BACKGROUND, SUMMARY AND TECHNICAL REVIEW OF
"CONCEPTUAL CONSIDERATIONS OF THE YUCCA MOUNTAIN GROUNDWATER
SYSTEM WITH SPECIAL EMPHASIS ON THE ADEQUACY OF THIS SYSTEM TO
ACCOMMODATE A HIGH LEVEL NUCLEAR WASTE REPOSITORY"
BY J. L. SZYMANSKI, JULY 1989

Hydrologic Transport Section
HLGP, DHLWM, NMSS
US Nuclear Regulatory Commission
May 24, 1990

"Conceptual Considerations of the Yucca Mountain
Groundwater System with Special Emphasis on the
Adequacy of this System to Accommodate a
High-Level Nuclear Waste Repository"
by Jerry S. Szymanski, US DOE
Las Vegas, Nevada, July 26, 1989

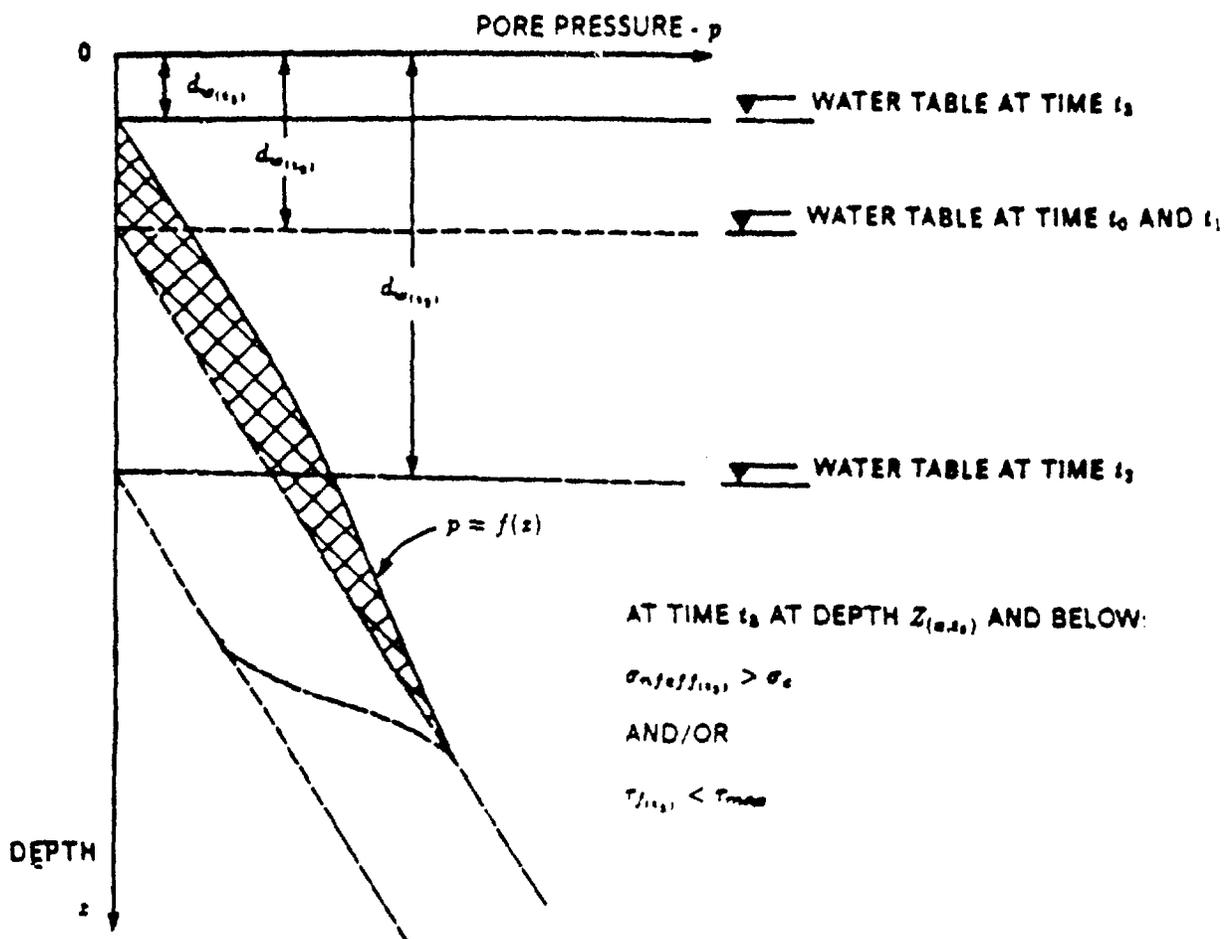
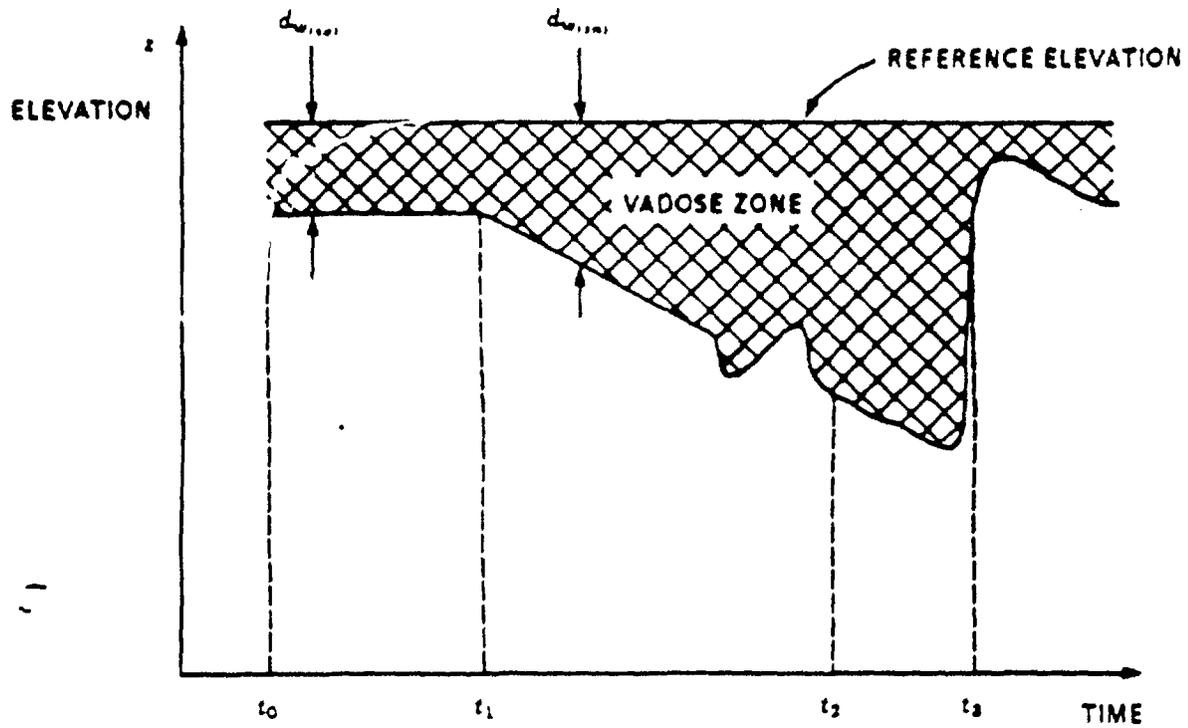
The lack of perspective or scale (note that there are no time or length scales in Figures 1 and 2) make it difficult to evaluate the significance of Mr. Szymanski's hypothesized process with respect to repository performance. What depth is needed for "a deep exploratory borehole"? The repository is situated in the top 1 km layer of hydro-thermal-stress system that extends to 15 or 40 km deep (Cathles, 1990) depending on how far one wants to carry the problem. To what depths should borehole investigations be made and what should be the boundaries of the system for the evaluation of performance. To date, the HTS has not had a concern about exploring depths beyond those already existing or planned in the saturated zone.
